Notice of Allowability	Application No.	Applicant(s)	
	09/727,113	RAZZELL, CHARLES JOHN HENDERSON	
	Examiner	Art Unit	
	Juan A. Torres	2631

EXAMINER'S AMENDMENT

1st OA

DETAILED ACTION

FIG. 1 (Prior Art)

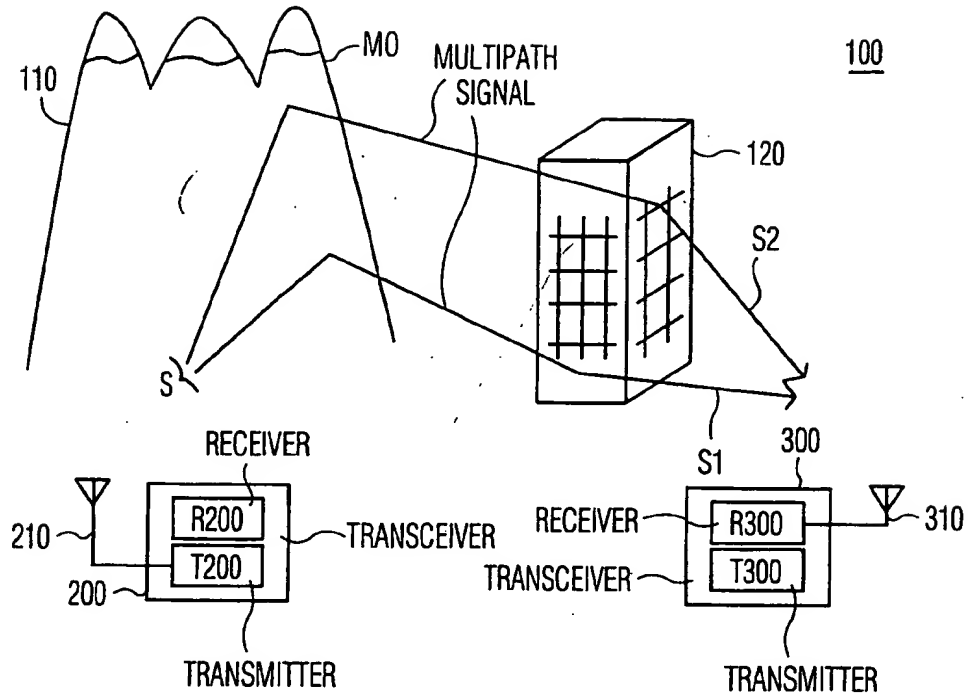
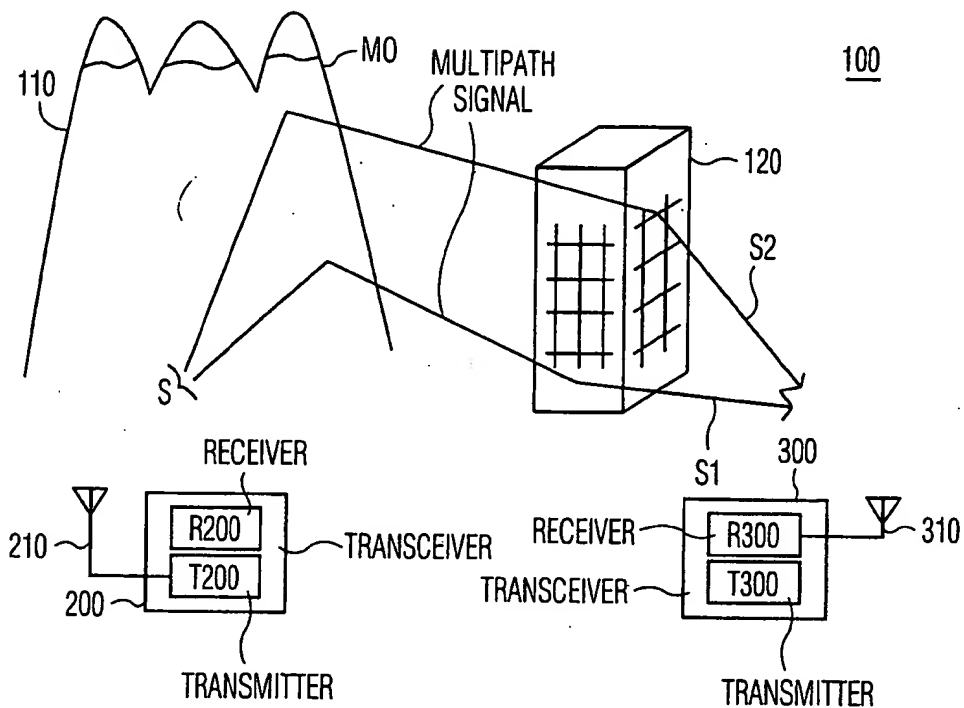
Figures 1-3 should be designated by a legend such as --Prior Art-- because only that which is old is illustrated. See MPEP § 608.02(g). Corrected drawings in compliance with 37 CFR 1.121(d) are required in reply to the Office action to avoid abandonment of the application. The replacement sheet(s) should be labeled "Replacement Sheet" in the page header (as per 37 CFR 1.121(d)) so as not to obstruct

Please accept the attached replacement sheets of FIGS. 1-3.

FIG. 2 (Prior Art)

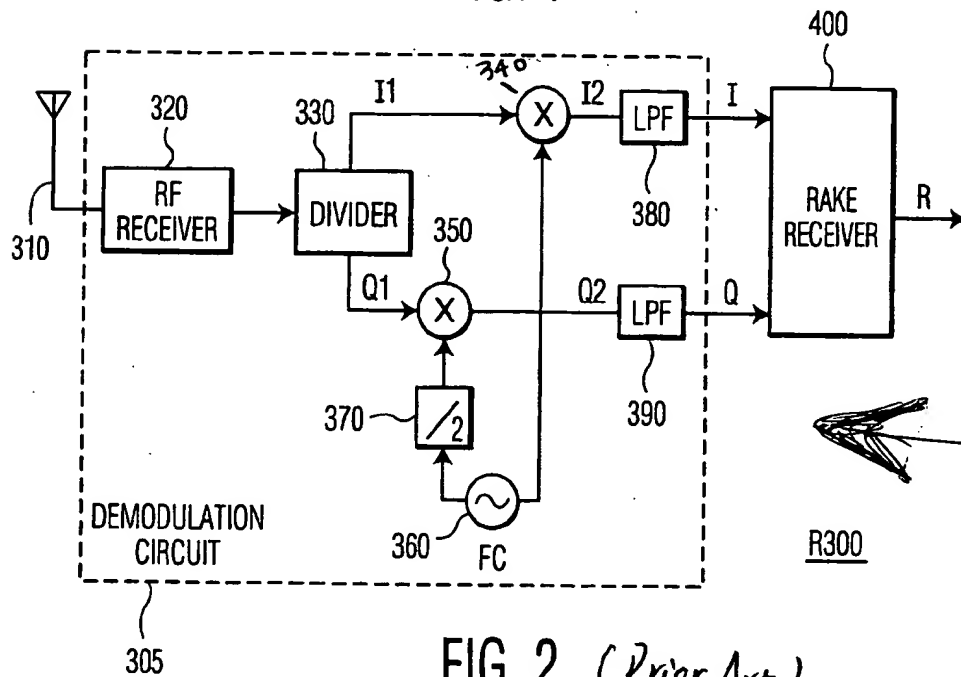
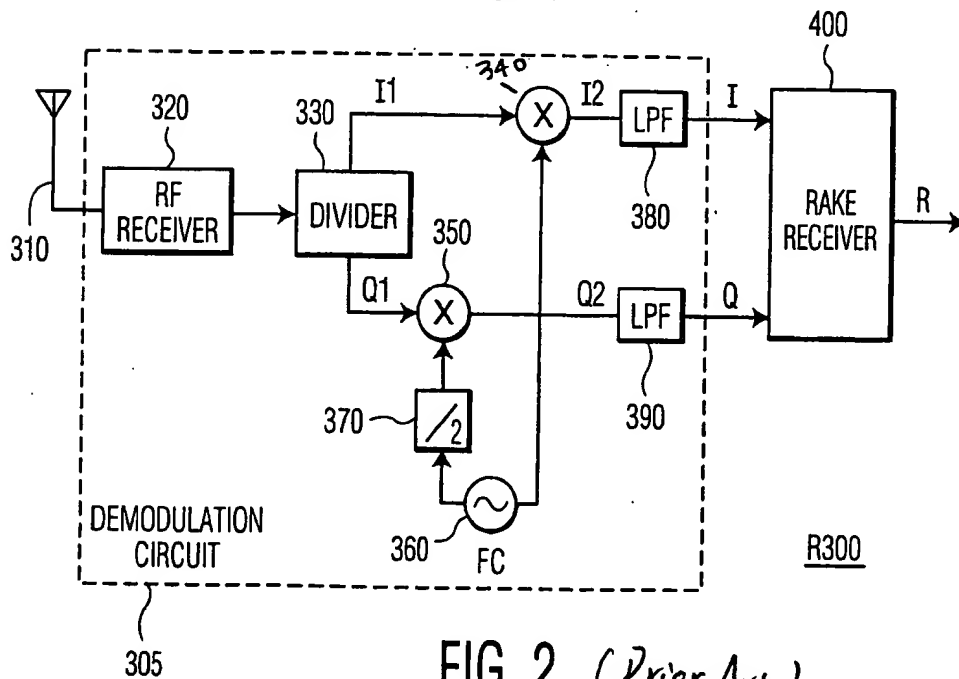
The following changes to the drawings have been approved by the examiner and agreed upon by applicant: in FIG. 2 block 370 the recitation " $/2$ " is changed to " $\pi/2$ ". In order to avoid abandonment of the application, applicant must make these above agreed upon drawing changes.

In FIG. 2 block 370 recites " $T/2$ " it is suggested to be changed to " $\pi/2$ " how it is described in the disclosure in page 7 line 4.

In FIG.2 block 340 as described in page 6 line 32 of the specification.

- a) In FIG. 2 block 370 the recitation " $/2$ " is changed to " $\pi/2$ ".
- b) In page 10 line 8 the recitation " $K4^*E > K3^*L$ " is changed to " $K4^*L > K3^*E$ ".
- c) Claim 3 is cancelled.

FIG. 3 (prior Art)

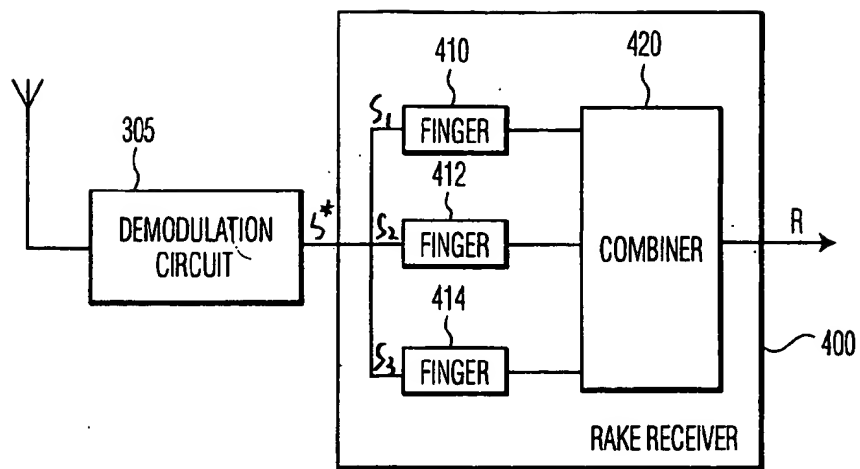
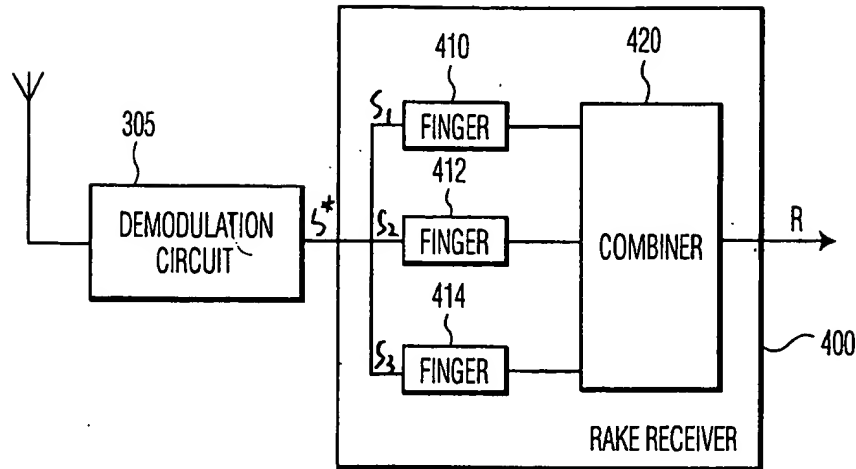
In FIG.3 block S* as described in page 7 line 14 of the specification.

In FIG.3 block S1, S2 and S3 as described in page 7 line 17 of the specification.
